Product Change Notice (PCN)

Subject: Change PCB Supplier for Flow Sensors Products

Publication Date: 7/1/2021

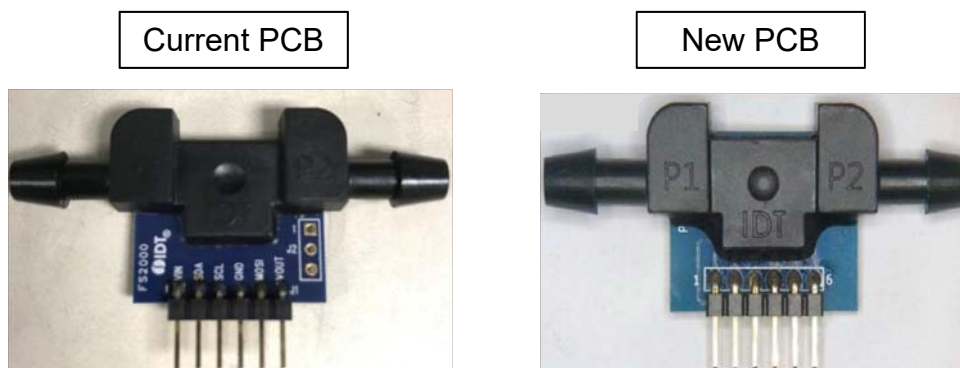
The change will have no impact on the function, quality, reliability and environmental compliance of the products. However, the form and fit are changed as depicted in page 1.

Solder mask color where blue denotes new PCB whereas dark blue denotes old PCB.
